PLAN 1

PLANNING APPLICATION PLN-21-0152

80 MAIN ROAD, PERTH

Description of proposal: CHANGE OF USE FROM SERVICE
INDUSTRY TO FOOD SERVICES, EXISTING
CARSTAKER DWELLING TO BE RETAINED
VARY PARKING REQUIREMENT

Backyard which could be re-developed to car park showing current use (not as car parking)

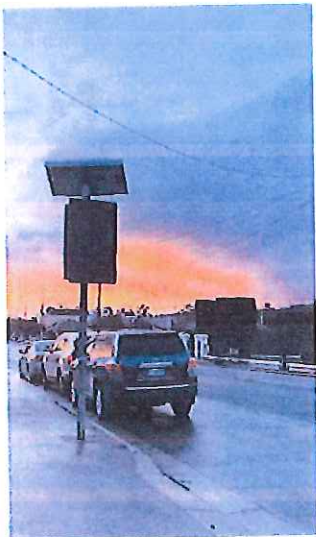
The Application asserts *"there are currently three spaces on site and little room to expand on this."* This is not accepted as the rear garden area at 80 Main Road where the caretaker apparently parks could be converted to provide the additional car and bicycle spaces required under the Code.

80 Main Road from corner Scone Street and Main Road showing back garden and current parking arrangements of occupant's vehicle (not in back yard as asserted by Applicant)

Mr Wyker will form three parking spaces within the rear garden area as shown in the plan below:

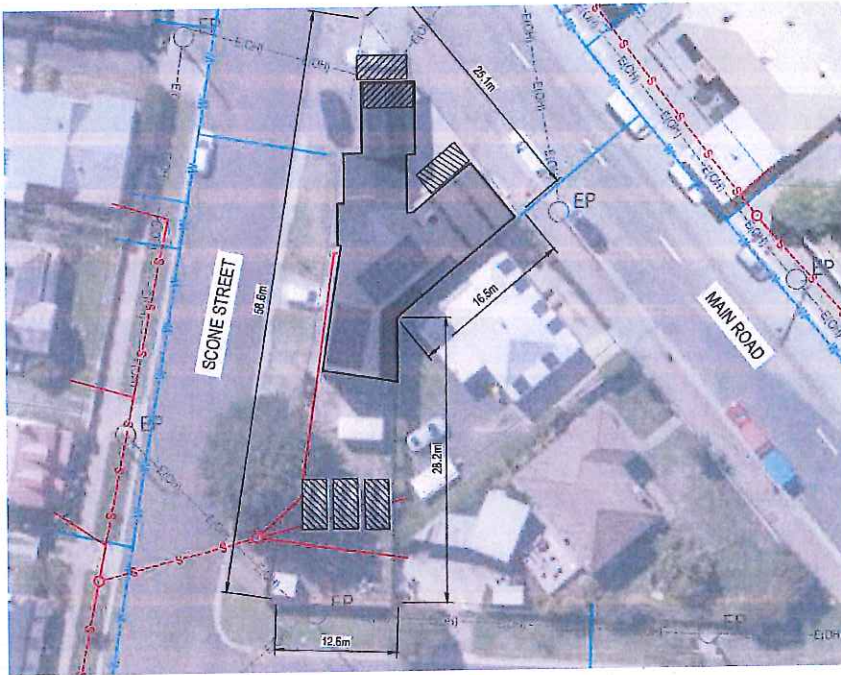
The representors talk about the bakery and another eatery currently causing parking issues. It is noted from a site inspection that the two properties provide on-site parking – but neither parking area is used extensively by customers. Providing parking and getting parking that is useful are two different things. If the parking is to the rear and not readily accessible then it will not be used.

In regard to bicycle parking Mr Wyker's company has a strong policy on its current site that any staff member who wishes to ride to work can park inside the building – they will not move on this risk minimisation strategy. Bicycle parking for the public should be provided by Council in safe locations – not randomly dotted around a town as part of planning permits.

Mr Wyker had planned to keep the bulk of the garden area as open space for the caretaker's unit. He had also wanted to get his packing business established before focusing on the retail component of the proposal.

“Prior to the use commencing a plan showing three car parking spaces formed in the rear garden area shall be submitted for the endorsement of (RELEVANT COUNCIL OFFICER). The spaces shall be formed in hardstanding and drained accordingly.”
